NETS Case Study 1: Effectiveness of ventilation layers in wooden houses

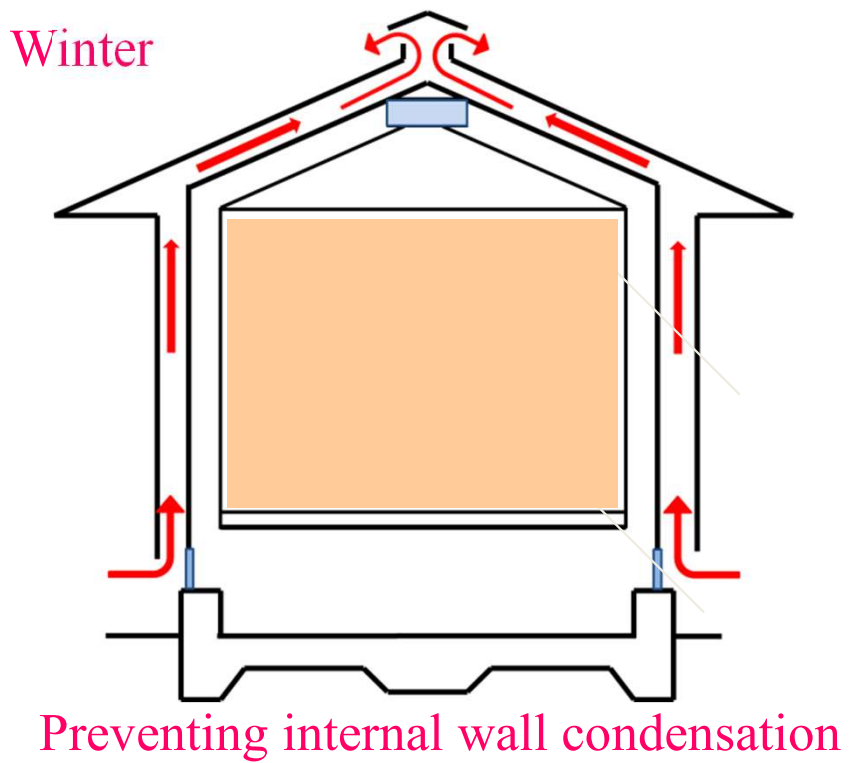
problems

- Isn't the thermal effect of the ventilation layer overstated?
 - Isn't it wrong to provide a ventilation layer on the indoor side?
 - Isn't the effectiveness of water vapor discharge important for durability and health?
 - Isn't it wrong for the ventilation layer to continue all the way to the top of the roof?
- Don't we need an isobaric zoning?
